REMARKS

Drawings

FG. 1

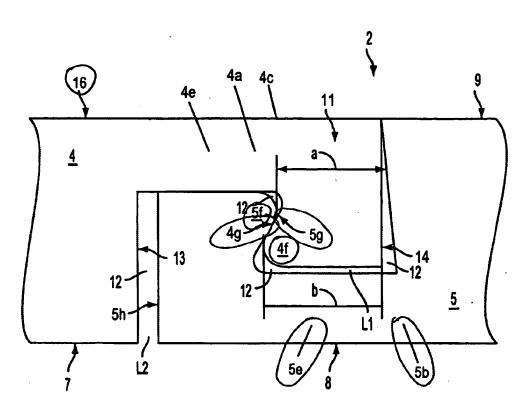
The Examiner objected to the drawings because reference character 4c points to different components. Figure 1 has been amended so that reference character points only to the hook element. The Examiner also objected to the drawings because reference character 5f should be similar to reference character 4f. Figures 2-4 have been amended to correctly indicate the hook projection. The Examiner further objected to the appearance of the fastening system depicted in Figure 1 as compared to the depiction in Figures 2 and 3 because the edges do not appear the same. Applicants assert that the difference in appearance is a function of the scale. The curvature involved has a radius of only a few millimeters. In the enlarged view of Figures 2 and 3, it is more obvious than in Figure 1. Nonetheless, the rounded feature is described in the specification on page 12, lines 22-24. Applicants respectfully request this objection be withdrawn.

FIG. 2

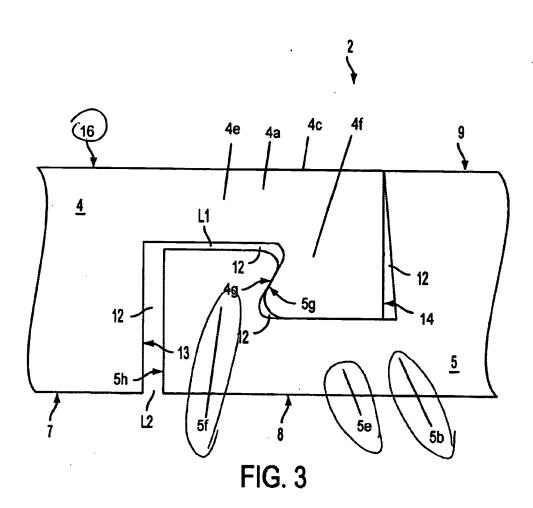
The Examiner objected to the drawings because reference character 4 points to a panel with a hook projection that, in Figure 2 forms a gap (L1) with the adjacent panel and in Figure 3 does not form a gap; furthermore, because reference character 5 points to a panel with a hook projection that, in Figure 2 does not form a gap with the adjacent panel and in Figure 3 forms a gap (L1). Applicants assert that these are merely different embodiments of the same invention using the same panels and that no additional elements are described, thus the same reference characters are used. Applicants respectfully request this objection be withdrawn. The examiner also objected to reference character 12 directed to a pocket that is enclosed and a pocket that is not enclosed. Applicants disagree. Reference character 12, in all instances, points to an adhesive pocket. While sometimes the adhesive pocket is surrounded by panel material and sometimes it is not, it is always merely a pocket. Applicants respectfully request this objection be withdrawn.

The Examiner objected to the drawings because reference character 5e was not included in the drawings. Figures 2 and 3 have been amended to include the reference character.

Furthermore, Figures 2 and 3 have been amended to change reference character 6 to 16, to avoid duplication of reference characters.
